**GENOA CHARTER TOWNSHIP
PLANNING COMMISSION PUBLIC HEARING
MONDAY, JUNE 13, 2016
6:30 P.M.
AGENDA**

Attention:	Kelly Van Marter, AICP Planning Director and Assistant Township Manager
Subject:	Seaside Seawalls – Special Land Use and Site Plan Review #2
Location:	Victory Drive – east side of Victory Drive, south of Grand River Avenue
Zoning:	IND Industrial District

Re: Seaside Seawalls Site Plan Review 2

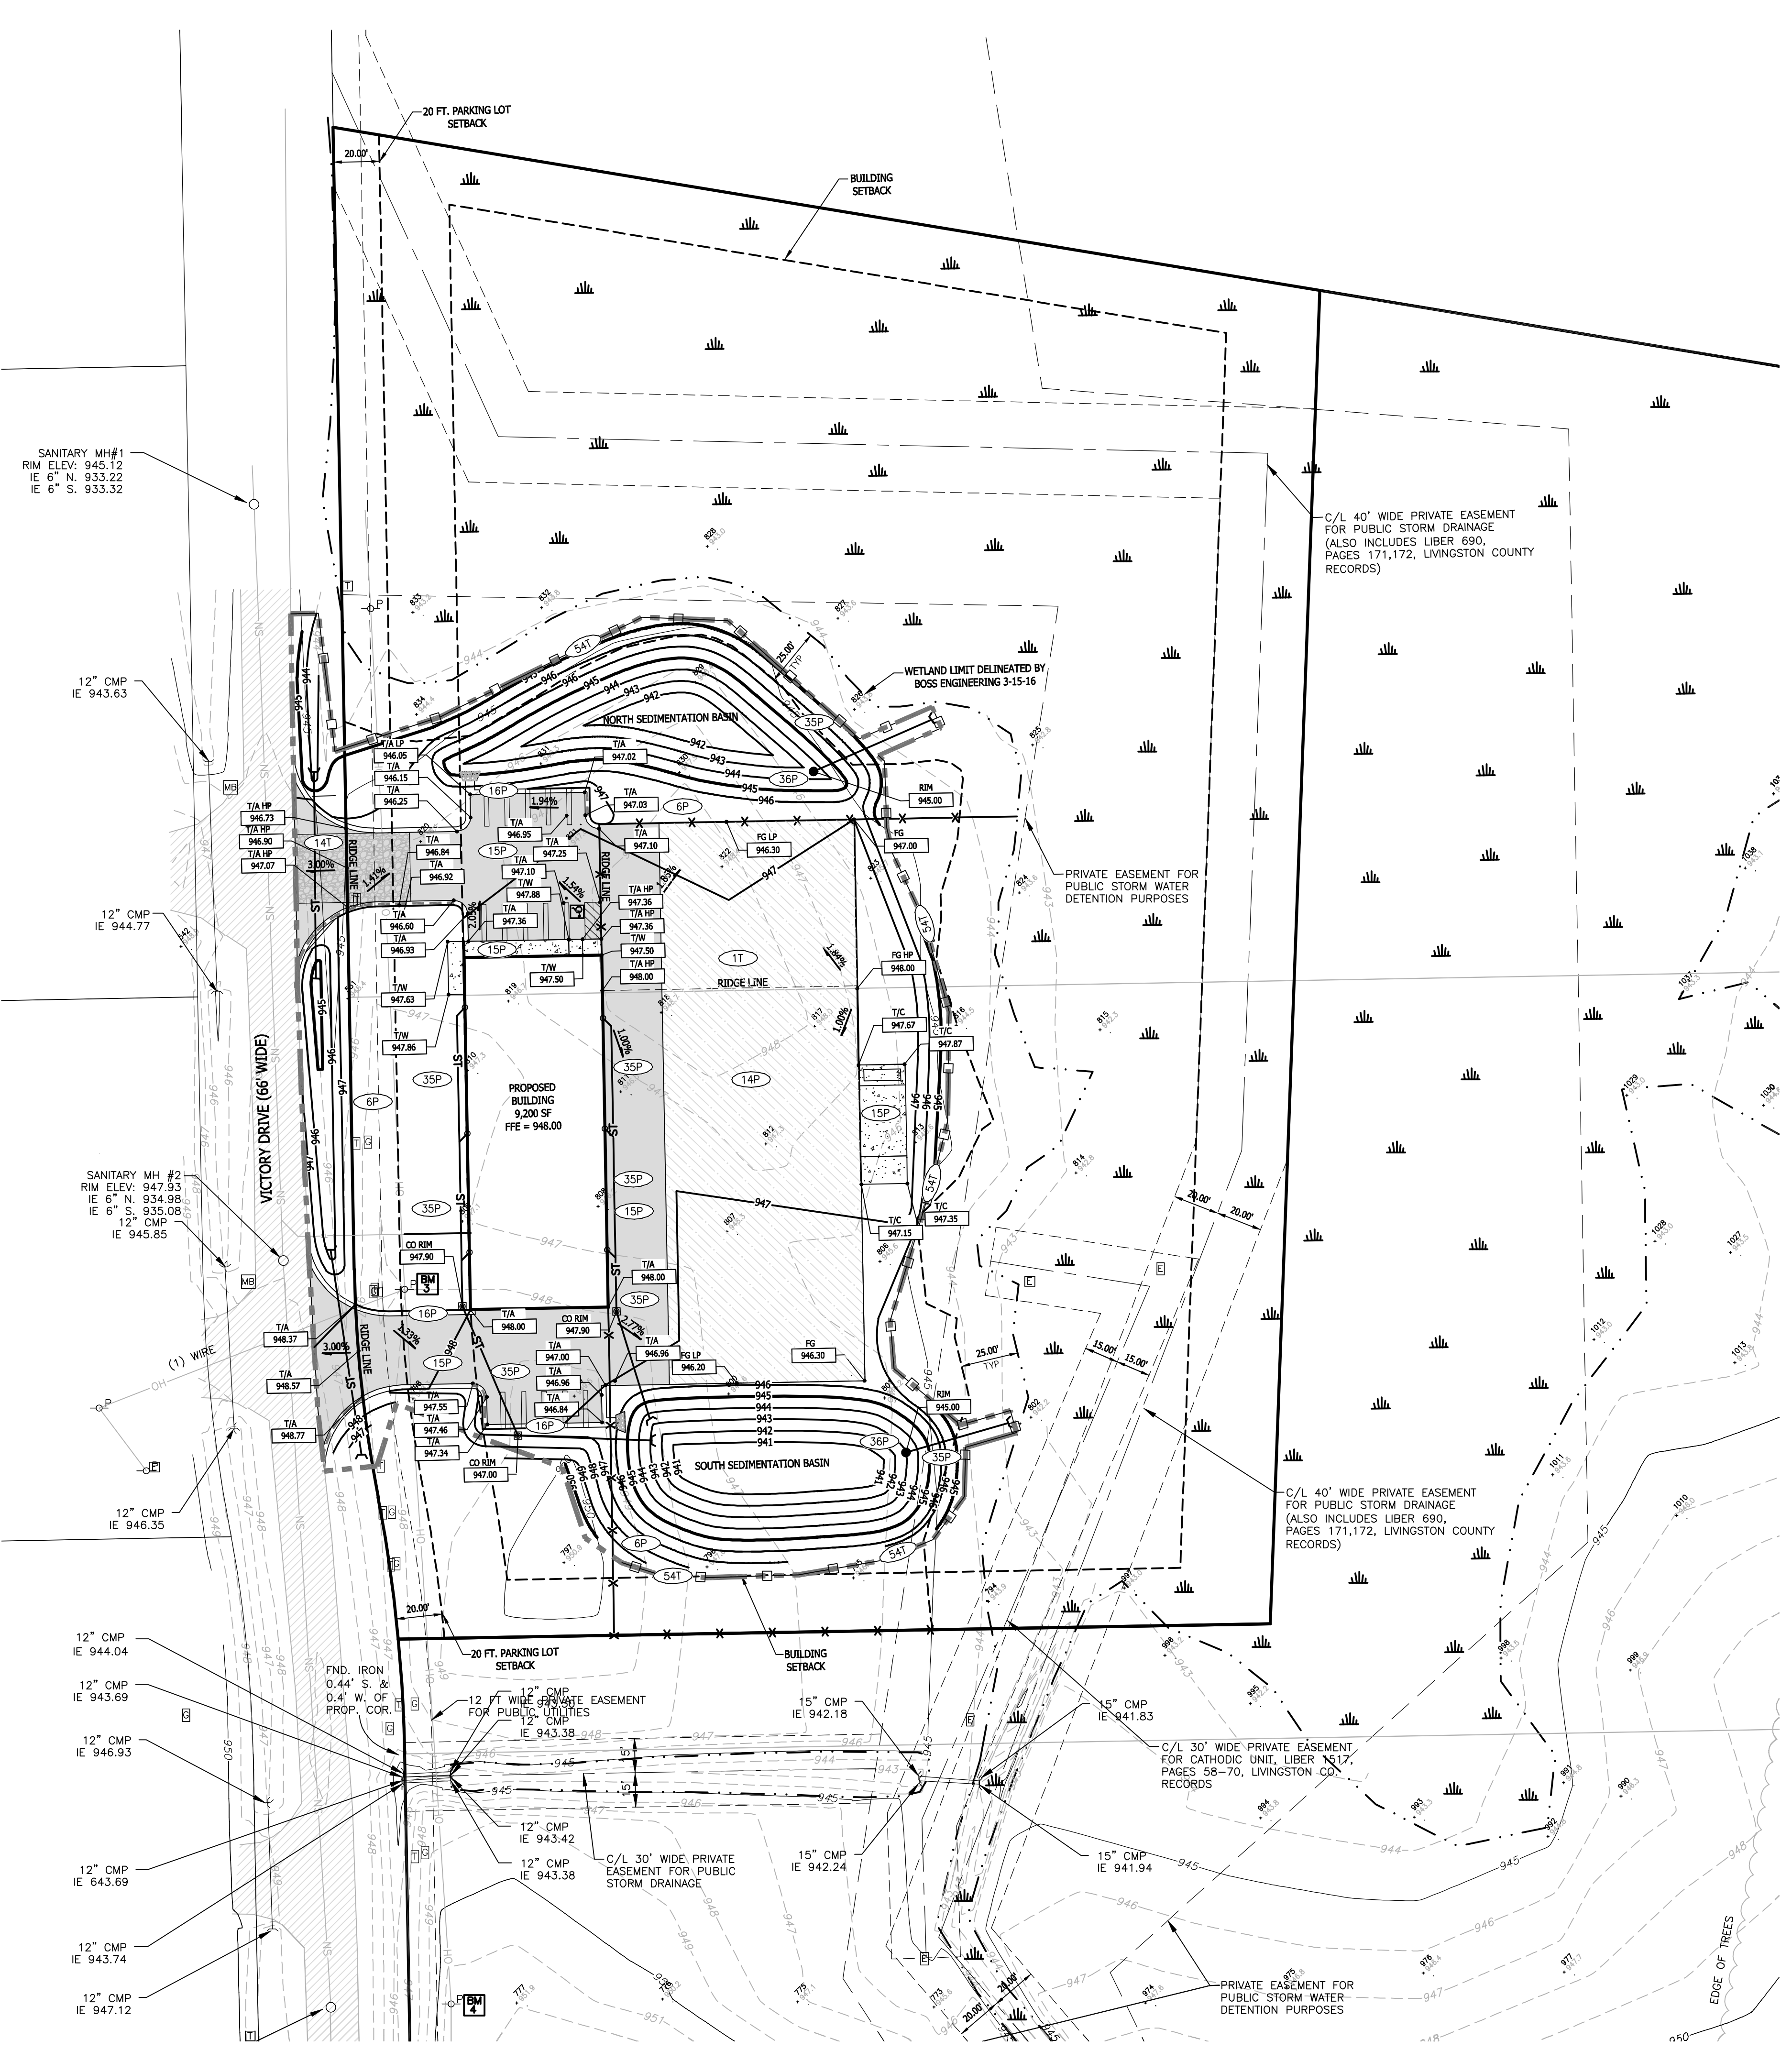
The site plan includes a 20' x 52' concrete pad for storage and waste receptacles. The larger area to the west is proposed as gravel. Given the proximity of wetland areas to the site, the use of gravel is likely to reduce stormwater run-off, which could be a benefit; however, we defer to the Township Engineer for specific comments on this aspect of the proposal.

The spacing standards on all sides and planting requirements on the south side are met; however, the planting requirements for the north and east side are not met and there is no screen wall/fence or berm.

The submittal does not describe the height of materials to be stored outdoors. The applicant needs to provide this information.

- 7. Waste Receptacle and Enclosure.** The site plan identifies a concrete pad in the rear yard with a note that it is intended for storage bins and a dumpster. However, the note also states that screening is not proposed due to limited visibility.

- 10. Fencing.** The rear yard is enclosed by security fencing, including gates at the two driveways. The revised plan includes a detail showing a 6-foot tall chain link fence with 1-foot of barbed wire across the top. The proposed fencing, including the barbed wire, complies with the standards of Section 11.04.04. As a side note, the northerly fence line runs all the way to the edge of the wetland, thus encroaching into the 25-foot wetland setback.

PROJECT:
PREPARED FOR:
DATE: 05/25/16
GENOA TOWNSHIP PER
REVISION NO. BY:
DESIGNED BY:
DRAWN BY: GAW
CHECKED BY:
SCALE: 1" = 40'
JOB NO. 16-049
DATE: 03/30/16
SHEET NO. **4**

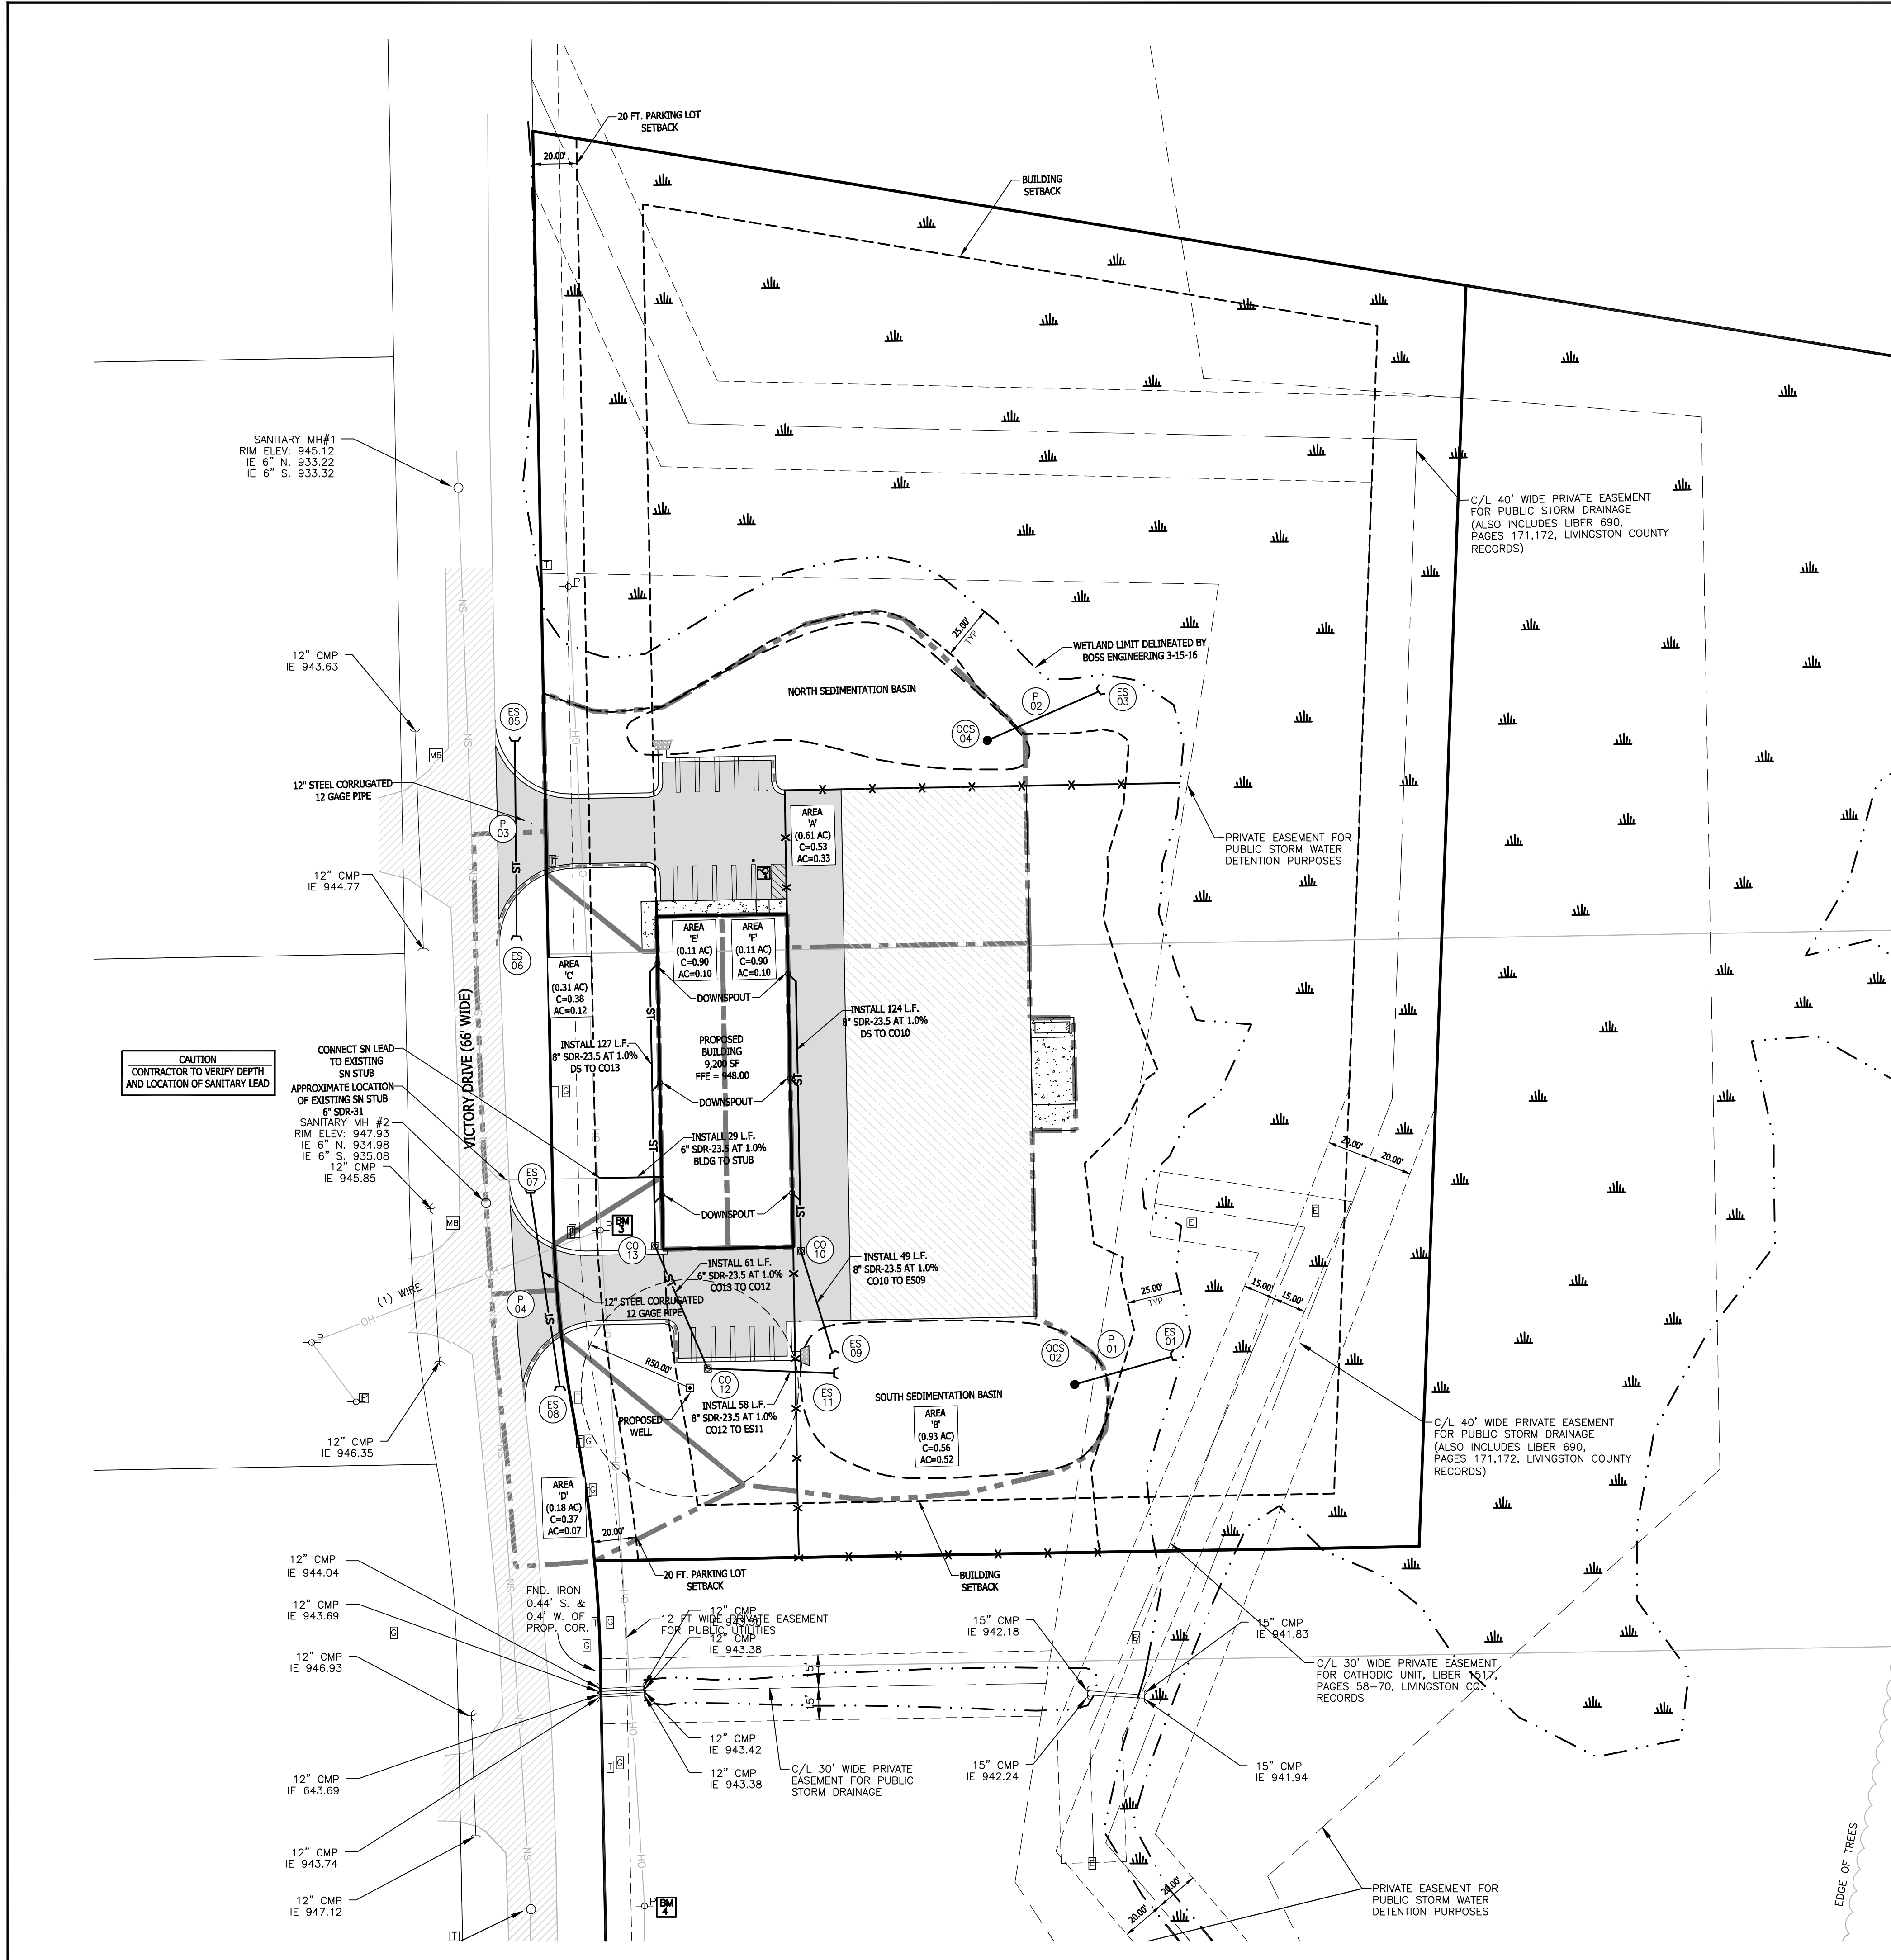
4. Planning Commission approval is required for the sedimentation basin outlets, which encroach to the edge of the wetland.
5. A variance from ZBA is required to extend fencing to the edge of the wetland. We encourage the applicant to stop the fence at the 25-foot wetland setback, as opposed to seeking a variance.

3. Proposed approach grades at the connection to Victory Drive and around the radii need to be provided on the plan to verify that no portion of the approach exceeds a grade of 5% and to verify that there is sufficient cover over top of the proposed approach culverts.
